Access Compliance Report Public Rights-of-Way (Curb Ramps)

Intersection ID: 50710 Main Street: STEELE_CREEK_RD Cross Street: ARRIVAL_DR Location: NW

ADA ID: C5DDB3389090 Ramp Type: Combination1 Initial Pass/Fail: Fail Overall Compliance: No Severity Score: 21.25

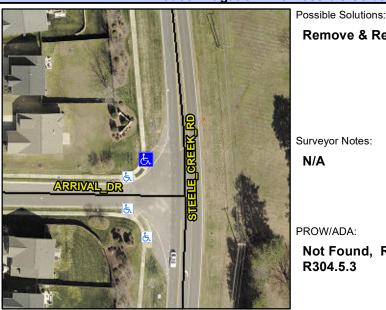
| Possible Solutions: |
|--------------------------------|
| Not Found, R304.5.1, R304.5.1, |
| R304.5.3 |

| Possible Solutions: |
|--------------------------------|
| Remove & Replace Entire Ramp. |
